MEMORANDUM

TO: District of Columbia Zoning Commission
FROM:  Joel Lawson, Associate Director, Development Review
DATE: April 23, 2018
SUBJECT: Large Tract 2017-07 – NASH-Roadside 3900 Wisconsin LLC (Square 1823, Lot 801)

SITE PLAN 01

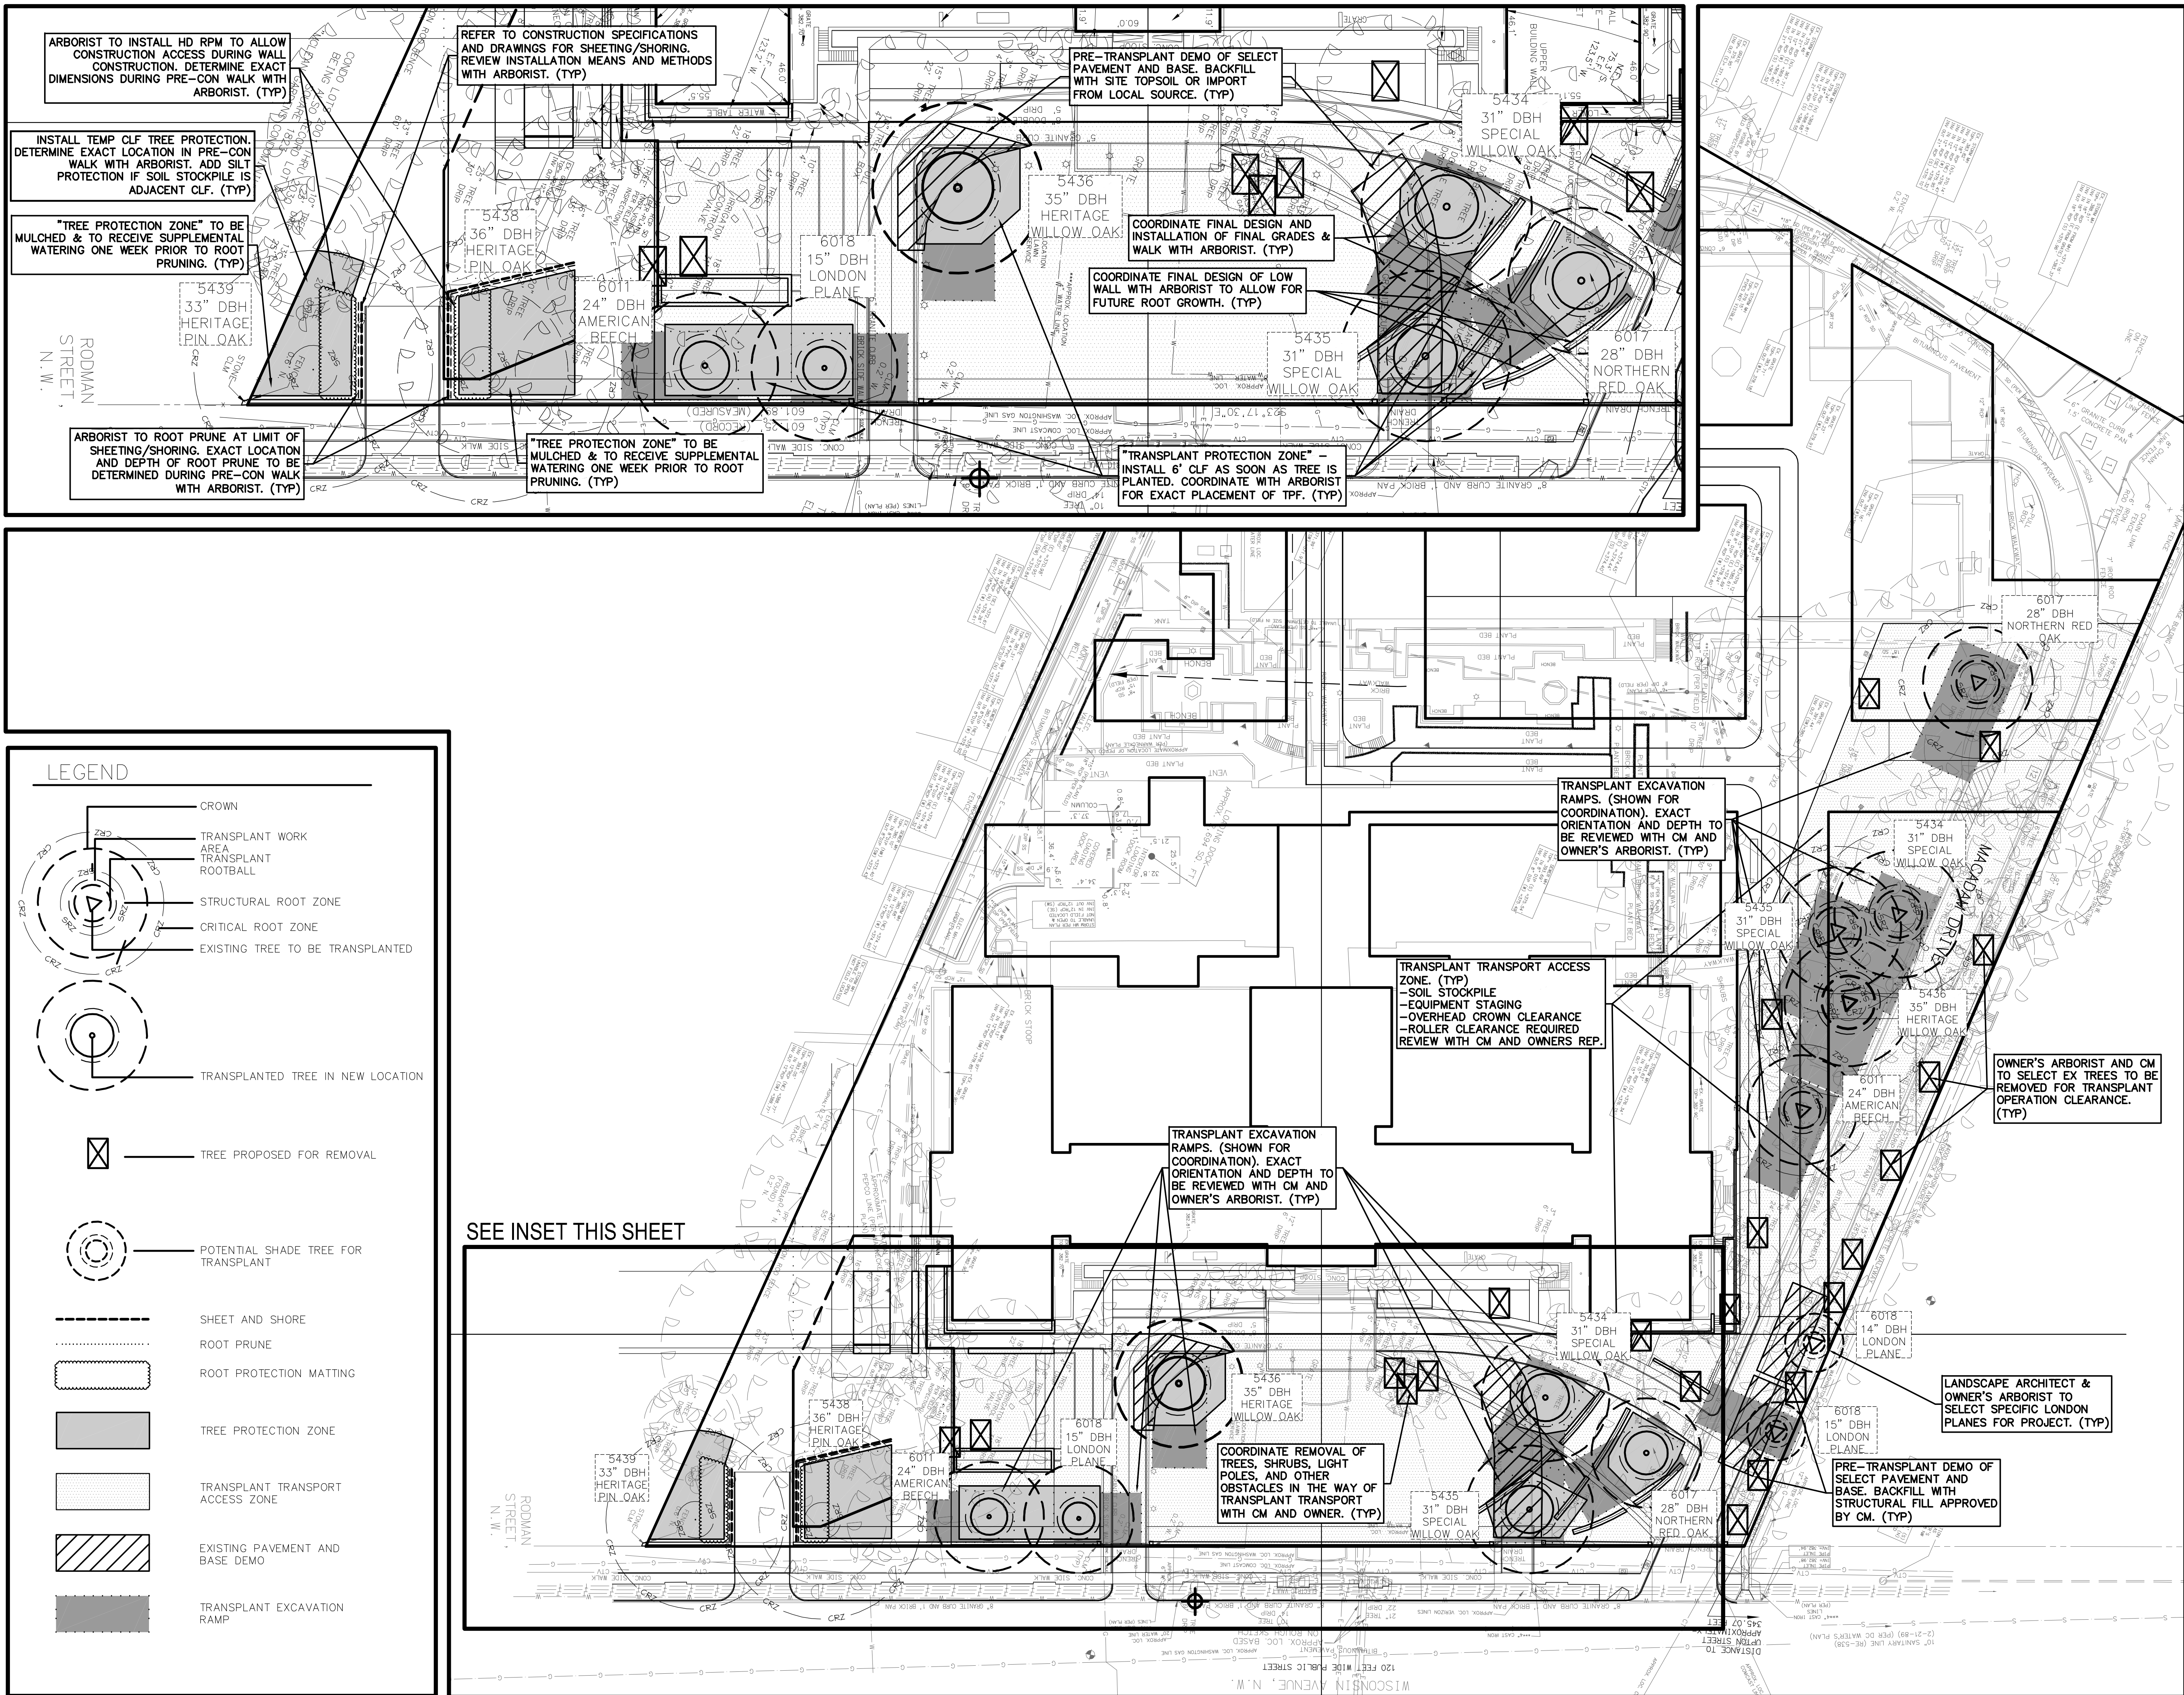
The applicant has indicated that no relief from zoning is needed. The drawings submitted, however, appeared to show penthouse area which may not provide the required 1:1 setback (see applicant submission drawing 17). The applicant confirmed that all penthouses would provide all required setbacks, and provided an updated roof plan, attached to this report as Attachment I.

Figure 1 – Site Plan (Source: Shalom Baranes Associates, 1/4/18, Z-02)

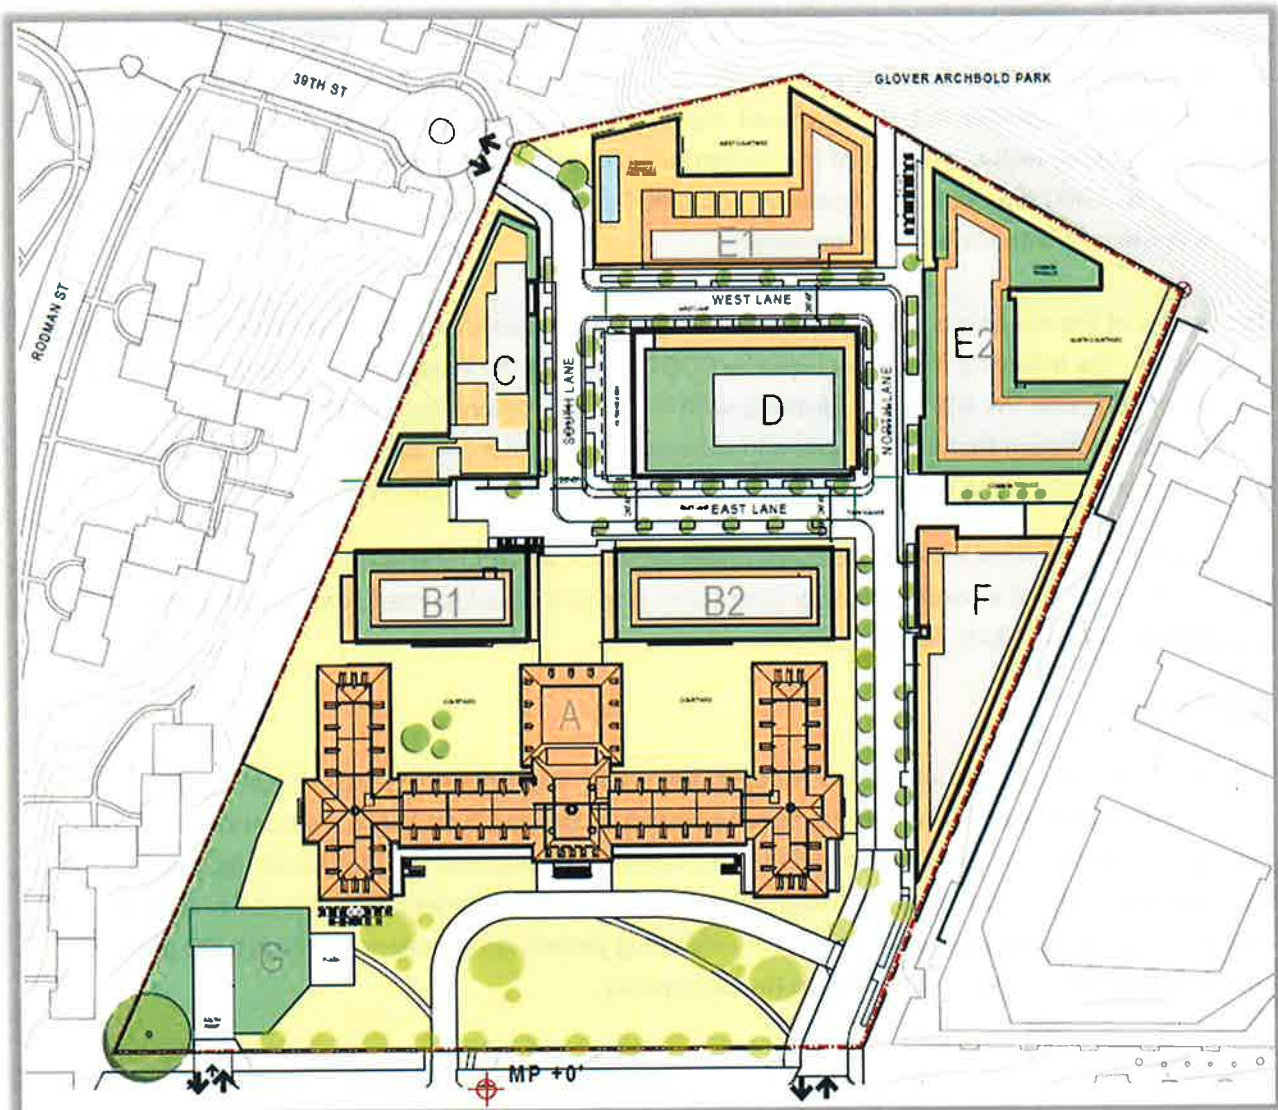
Primary vehicular access to the property will be via three (3) driveways, two (2) on Wisconsin Avenue NW (at North Lane and the southern signalized driveway) and one (1) via the cul-de-sac on 39th Street NW. A reconfigured one-way semi-circular driveway serving as the pick-up and drop-off area for the proposed hotel will be provided in front of the 3900 Wisconsin Avenue property connecting from North Lane to Wisconsin Avenue.

There will be two (2) access points to the underground parking garage. One is proposed from Wisconsin Avenue NW at the southern end of the site. This entrance will be proposed to be signalized and also will serve as the only access point for delivery trucks (see discussion in Mitigations section regarding signalization). The other entrance to the garage will be at the northern end of the site from North Lane approximately 300 feet west of the existing signal. There was initially a third entrance to the parking garage proposed near the driveway from 39th Street NW, however that has been removed in recent iterations of the site plan. Figure 1 below shows the most current proposed site layout.

Figure 2 – Ground Level Loading Area (Source: Shalom Baranes Associates, 9/18/17, Page 12)

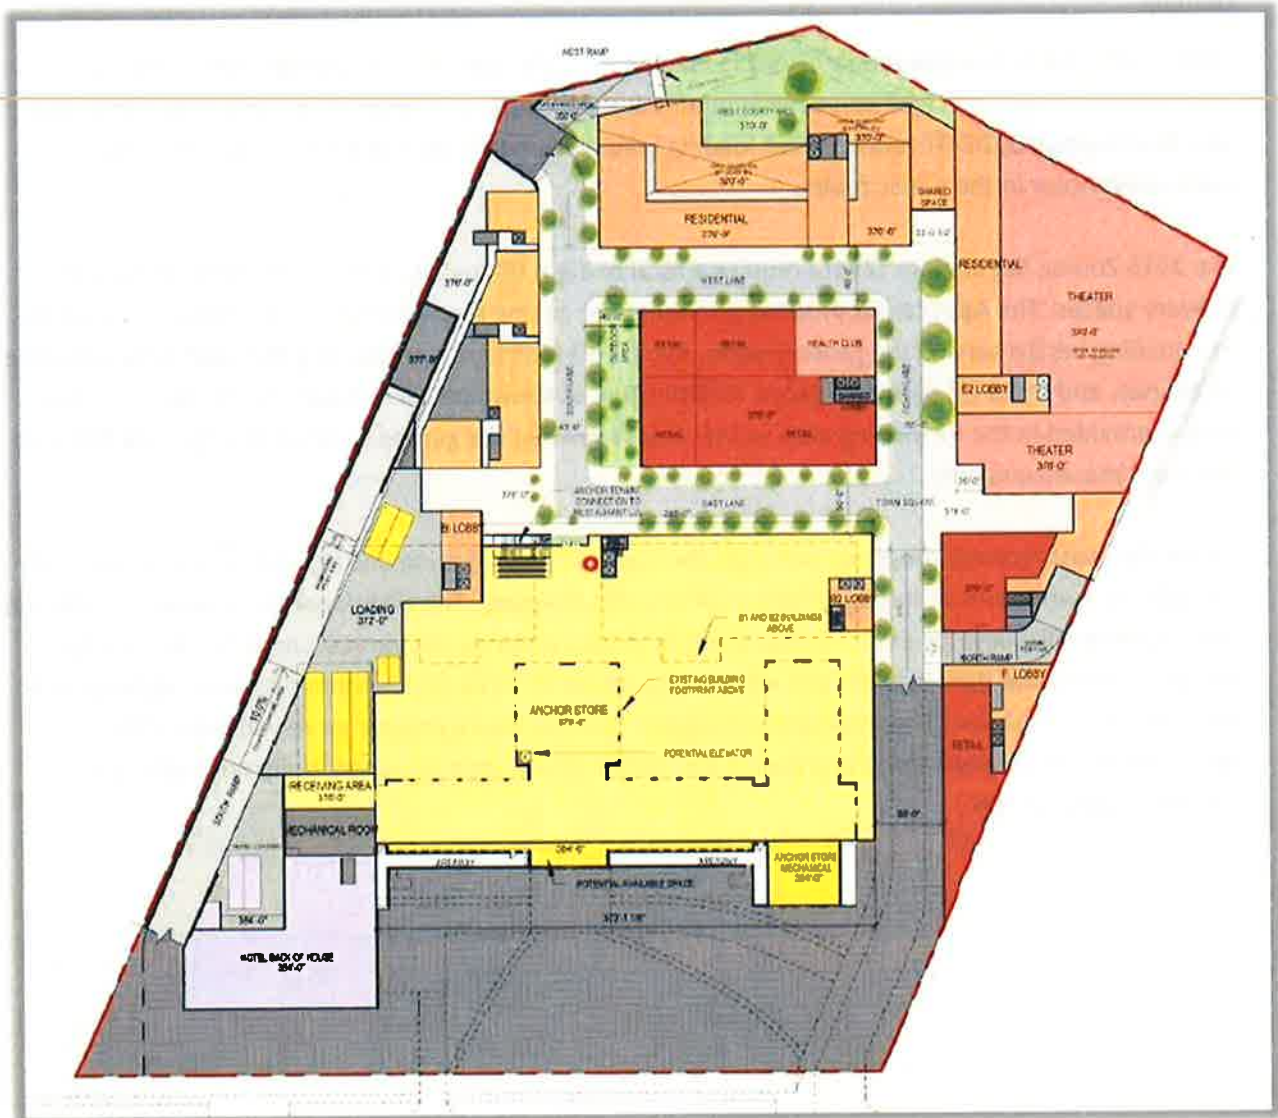
The 2016 Zoning Regulations (ZR16) require a total of eight (8) loading berths and three (3) 20-foot delivery spaces. The Applicant is proposing to meet the zoning requirements by providing three (3) 55-foot loading berths serving the grocery store, five (5) 30-foot berths supporting the residential and other retail uses, and three (3) delivery spaces. Additionally, as shown below in Figure 3, a truck turnaround loop is provided in the P2 loading area so that trucks can exit the garage to Wisconsin Avenue NW with head-out maneuvers only.

Figure 3 – P2 Level Loading Area (Source: Shalom Baranes Associates, 9/18/17, Page 12)

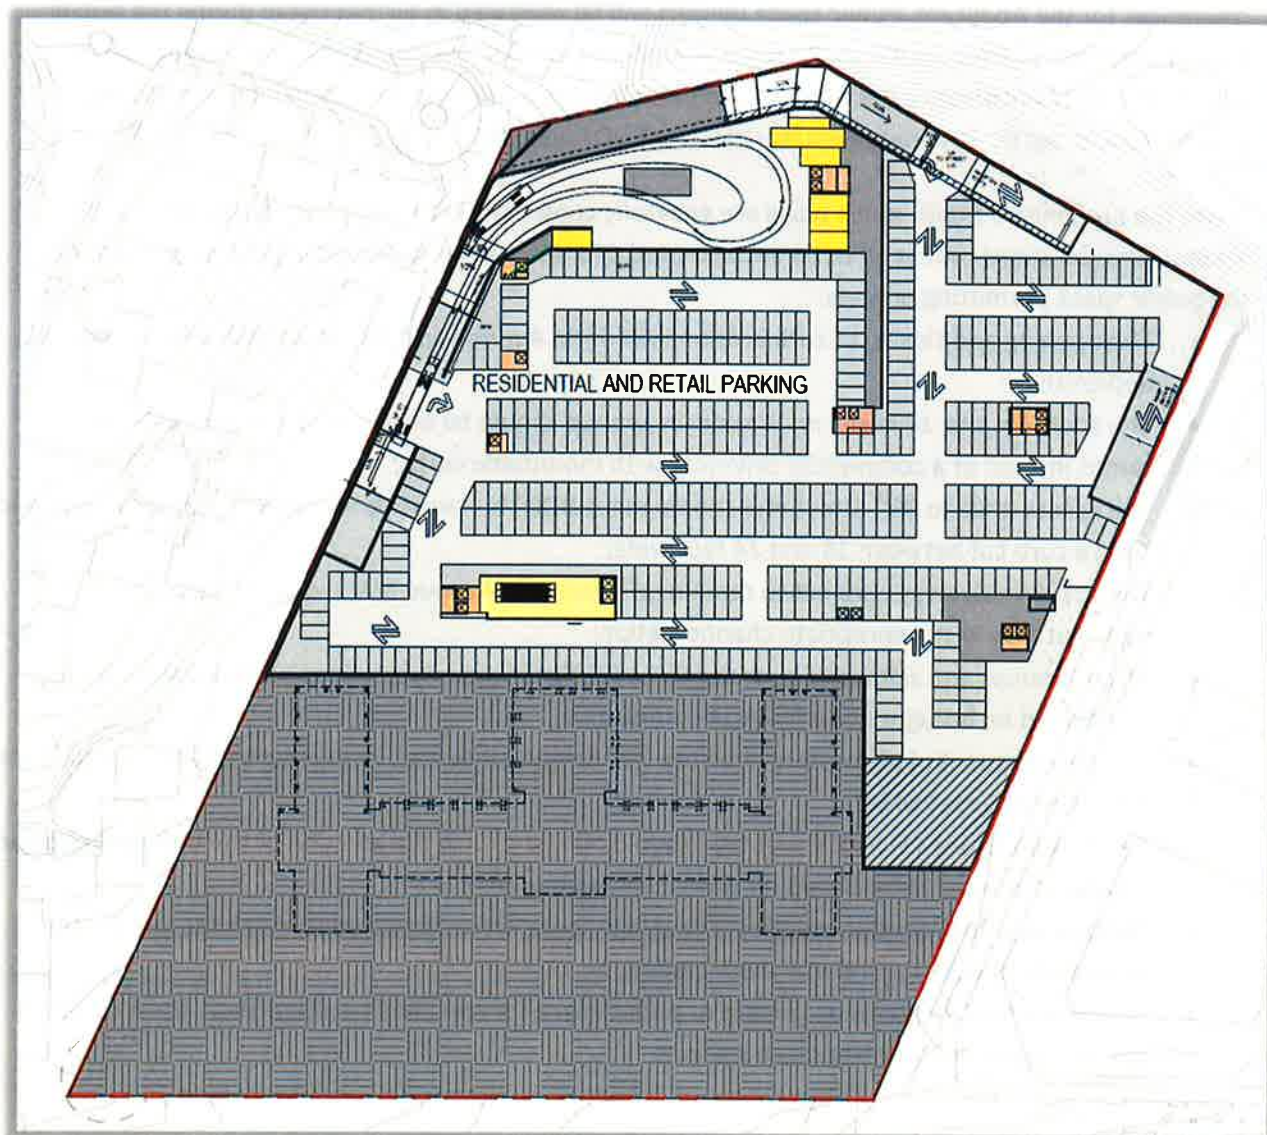
Under the most recently proposed concept, the Applicant is proposing one (1) wide inbound lane and two (2) outbound lanes at the signalized southern site driveway. The additional space provided with the inbound lane will allow for extra turning space for trucks entering the garage. Large delivery trucks turning southbound right into the site will need to utilize all three (3) southbound travel lanes but will not cross the center line. The Applicant anticipates that the future grocery store will make their deliveries during off-peak times and during the middle of the night so as not to disrupt traffic on Wisconsin Avenue NW.

Figure 8 – Existing Pedestrian Infrastructure (Source: CTR, Gorove/Slade Associates, Figure 31, 9/18/17)

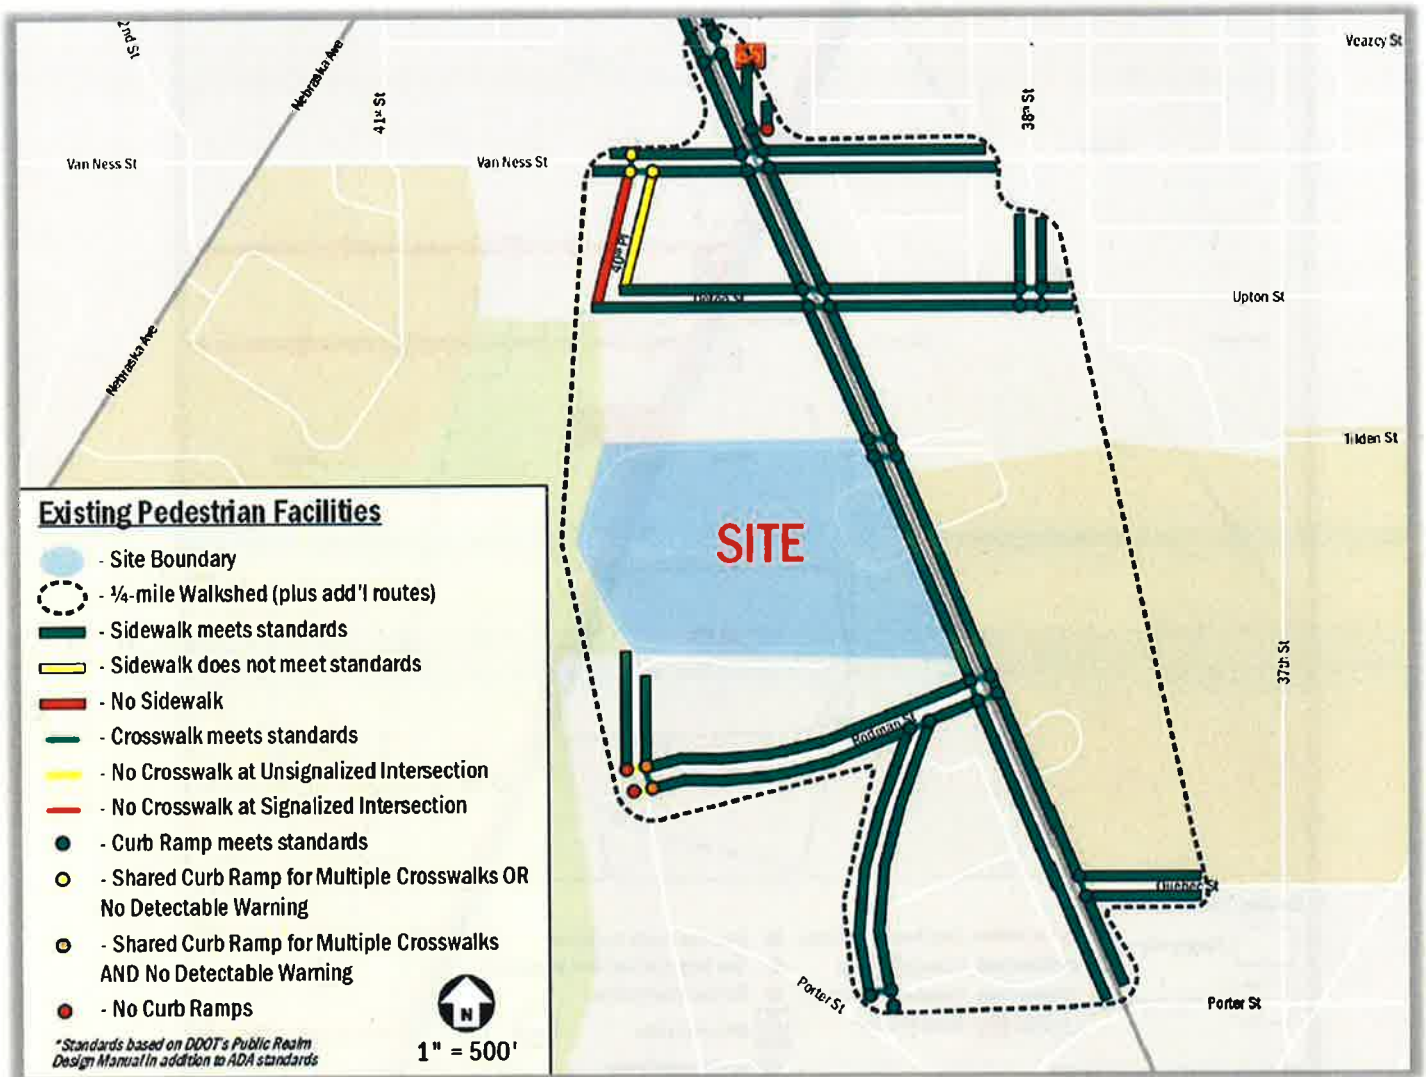
As shown above, the pedestrian network surrounding the site is almost entirely complete and up to DDOT standards. There is a missing segment of sidewalk at the end of the 39th Street NW cul-de-sac that would provide a critical pedestrian connection for the neighboring community to the new development. The Applicant should construct this missing sidewalk in conjunction with the 3900 Wisconsin Avenue project.
